APPLICATION FOR HOUSEHOLDER PLANNING PERMISSION DELEGATED REPORT

APPLICATION REFERENCE:	PL/2026/04070
APPLICATION TYPE:	Householder planning permission
SITE ADDRESS:	West Lodge, West Street, Barford St Martin, Salisbury, SP3 4AH
DEVELOPMENT DESCRIPTION:	Demolish existing garage, carport and outbuildings. Construct two storey side extension to house and internal alterations. Construct single storey outbuilding.
RECOMMENDATION:	That Planning Permission be GRANTED

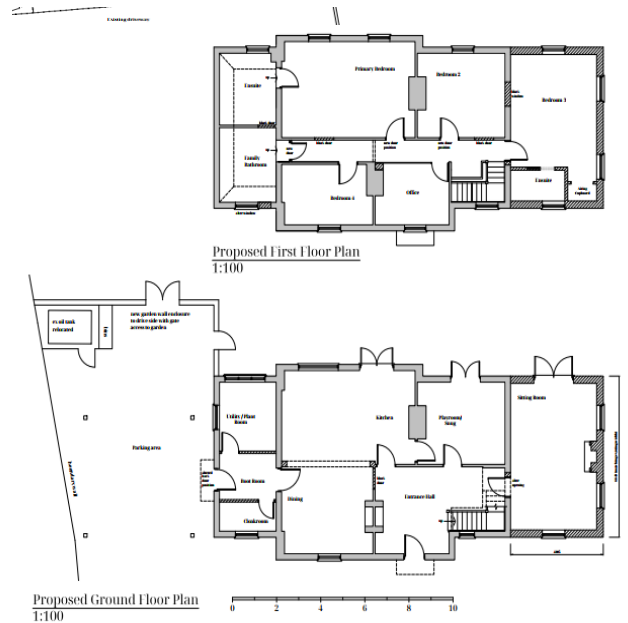
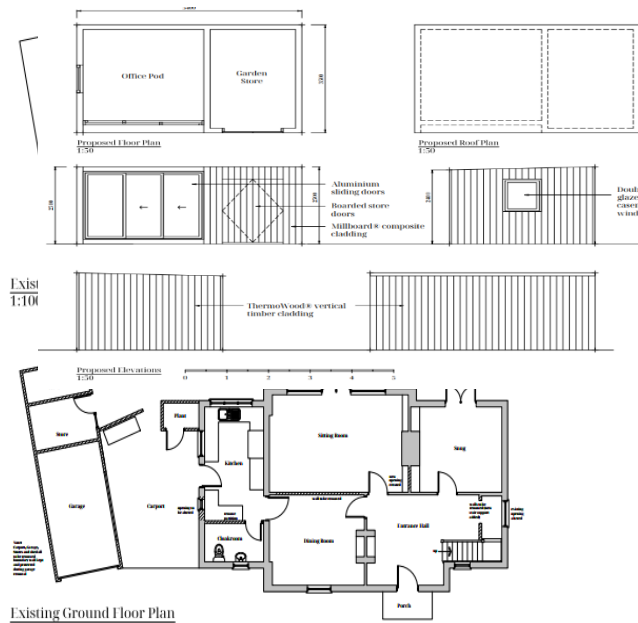
The host dwelling is a two-storey detached dwelling with a carport and a single storey garage attached to the eastern side of the host dwelling. This application proposes the demolition of a single storey carport and garage and the erection of a two-storey side extension on the west side of the host dwelling. The application site has had recent planning permission for the demolition of the existing garage, carport and outbuildings and the erection of a 2-storey side extension on the east of the host dwelling. This is now not proposed to be constructed. At the time of the site visit, July 2026, no works have started on site. Whilst there is an extant permission relating to the site, the two approved schemes overlap and cannot both be implemented in full. The applicant may choose which permission to implement; however, the commencement and implementation of one scheme would, by virtue of the overlapping development areas and associated parking arrangements, preclude the full implementation of the other permission. As such, there is no realistic prospect of both developments being constructed as approved.

The materials of the proposed extension are to be a textured block wall painted to match the existing with a hipped slate roof to match the ridge height of the existing west side off shoot of the host dwelling. The proposed extension is approximately 6.7 metres in width and 4.3 metres in length. The application also includes the demolition and replacement of the existing canopy on the front entrance door with a free-standing entrance canopy. All the windows on the northeast elevation (front elevation) are proposed to be replaced with new sash windows with the location of the windows on the existing east offshoot shifted to create a more symmetrical design. To the rear, (southwest elevation) the fenestration is also to be replaced with new sash windows with changes to the patio doors and windows on the ground floor. A new levelled terrace and planning beds are identified on the rear of the host dwelling but the terrace and fenestration elements are permitted development and do not therefore require planning permission. The application also includes the addition of a single storey pod and garden store to the east of the host dwelling.

The design, massing and height of the proposed extension match the existing host dwelling. The demolition of the single storey side extensions on the eastern side of the host dwelling are welcomed as the existing garage is in close proximity to the boundary shared with the neighbouring dwelling with the outbuildings are in need of improvement and modernisation.

The scale of the extension and proposed works on the western side are substantial and will significantly alter the appearance of the existing host dwelling. However, the host dwelling lies on a substantial plot of land with a large side and rear garden. As such, it is considered that the proposed extensions can be easily accommodated on the application site. The proposed side extensions are also to have a lower ridge height than the existing principal roof which will be seen as a continuation of the existing western off shoot and minimise the bulk and impact of the proposed side extension. Whilst visible from the public domain it is not therefore considered that the proposed addition will create a disjointed or strident addition to the main house and will have limited additional implications for the character of the conservation area or National Landscape. The additional floor space is also to provide an additional bedroom at first floor and a sitting room at ground floor. It is not considered that the additional floor space is excessive or opens up opportunities for subdivision or severance. This element of the proposals is therefore considered to accord with the above policy provisions.

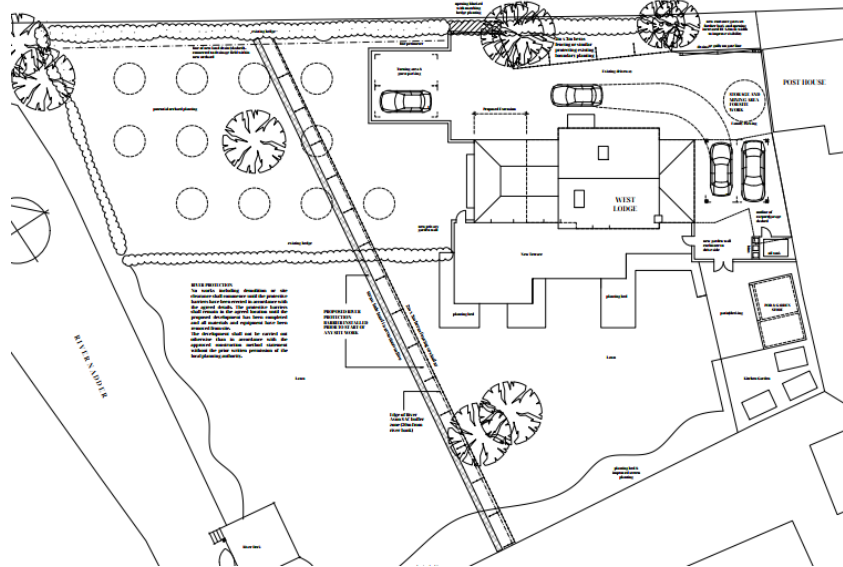
The applicant has clarified that the "River Protection Barrier" shown on Drawing WL21A (a snippet of which is shown above) comprises temporary Heras fencing and a straw bale bund which are proposed solely as construction-phase pollution prevention measures to protect the River Nadder during construction works. The measures are temporary and are not intended to function as a permanent flood defence.

On this basis, the drainage officer is satisfied that the previously requested assessment relating to the impacts of a flood defence barrier on floodplain storage and conveyance is not required. The temporary and porous nature of the proposed construction phase protection measures is unlikely to materially affect flood flow routes during their short period of use.
